Product hierarchy no. *				Part no.	SBU	Type / Description	Customer part no.
SBU	PG	PGU	Type				
01	001	007	0000000032	See list below	Circuit Protection	SPT 6.3x32 10-32A

SPT 6.3x32					
creation date	created by	release date	released by	notification no.	revision
11.2.2015	SHÖ	17.2.2015	SHÖ	xxx	1 von 1

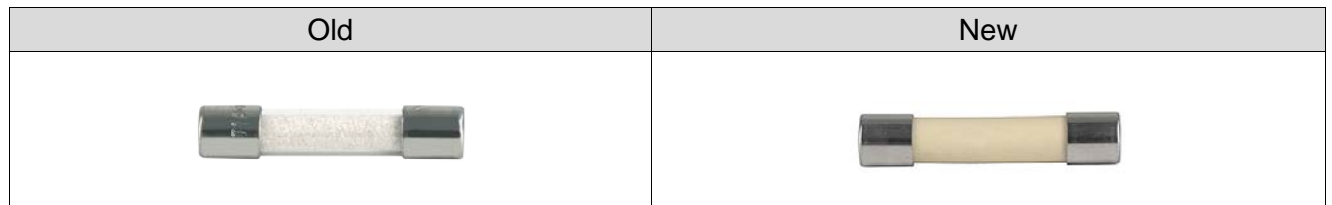
The tube material changed to ceramic.

Fuse element is now soldered internally to ferrules. Used to be soldered externally.

Form:	Yes	Tube material changed to ceramic
Fit:	No	No dimensional change
Function:	No	No functional change
Production Site:	No	Production site remains
